DART SERVICE INSTRUCTION

TO AMEND INSTALLATION INSTRUCTIONS: IIN-D206-667 REV. D

DESIGN	<i>PH</i>	DART AEROSPACE LTD	
DRAWN	<i>GP</i>	HAWKESBURY, ONTARIO, CANADA	
CHECKED	<i>A.P.</i>	DRAWING NO.	REV. P
MFG. APPR.	N/A	DSI 9346	SHEET 2 OF 2
APPROVED	<i>[Signature]</i>	TITLE	SCALE
DE APPR.	<i>[Signature]</i>	DEVIATION ON D206-667 & D407-667	NTS
DATE	12.05.07	COPYRIGHT © 2006 BY DART AEROSPACE LTD THIS DOCUMENT IS PRIVATE AND CONFIDENTIAL AND IS SUPPLIED ON THE EXPRESS CONDITION THAT IT IS NOT TO BE USED FOR ANY PURPOSE OR COPIED OR COMMUNICATED TO ANY OTHER PERSON WITHOUT WRITTEN PERMISSION FROM DART AEROSPACE LTD.

FIGURE 1 - INSTALLATION OF DART CROSSTUBES ON BHT/AAI SKIDTUBE

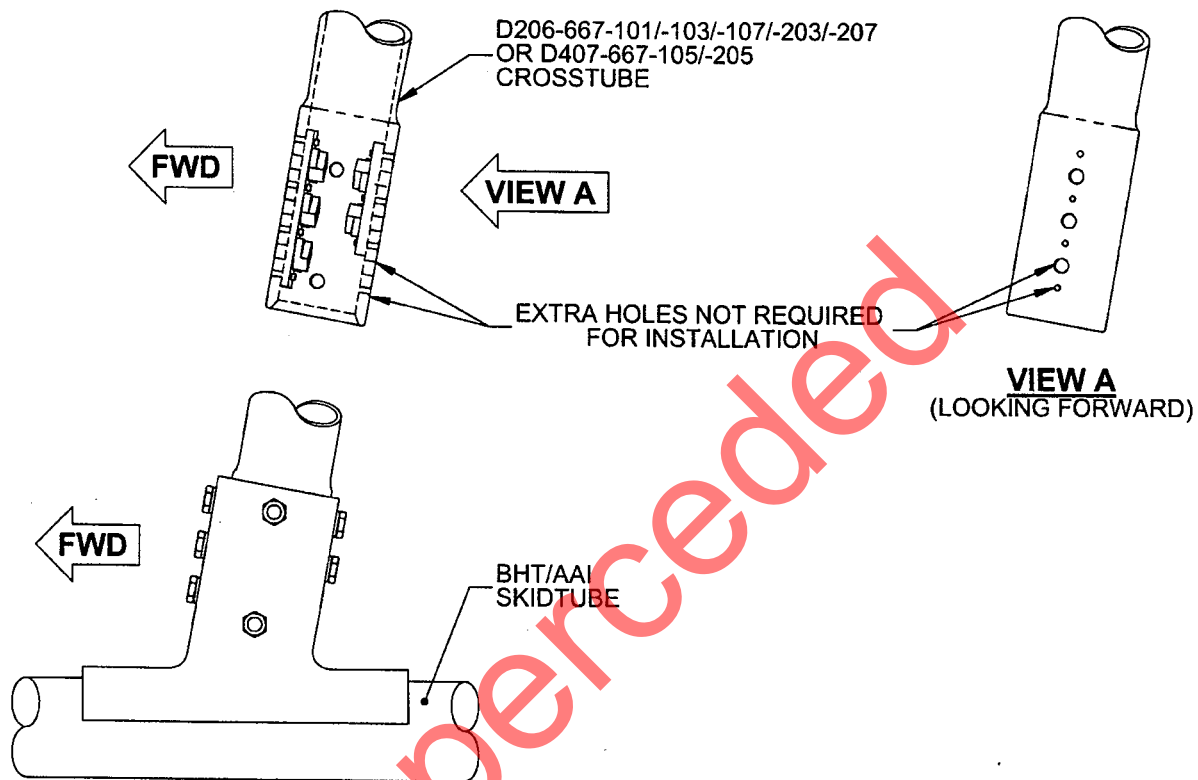
THE FOLLOWING D206-667-101/-103/-107/-203/-207 AND D407-667-105/-205 CROSSTUBES HAVE EXTRA HOLES DRILLED ON THE AFT SIDE OF THE CUFFS. THIS HOLE IS NOT REQUIRED FOR INSTALLATION OF DART CROSSTUBES ONTO BHT/AAI SKIDTUBES AS SHOWN IN FIGURE 1.

CUSTOMERS RECEIVING CROSSTUBES AT CHG 002 PRIOR TO 2006/08/08 SHOULD CONTACT DART FOR DISPOSITION IF INSTALLING THE DART CROSSTUBES ONTO BHT/AAI SKIDTUBES PER IIN-D206-667 REV. D.

CUSTOMERS RECEIVING CROSSTUBES AT CHG 002 PRIOR TO 2006/08/08 TO BE INSTALLED WITH DART SKIDTUBES MAY FIND THAT THE SUPPORTS HAVE BEEN INSTALLED BACKWARDS. THE SUPPORTS SHOULD BE REMOVED AND RE-INSTALLED PER ICA-D206-667.
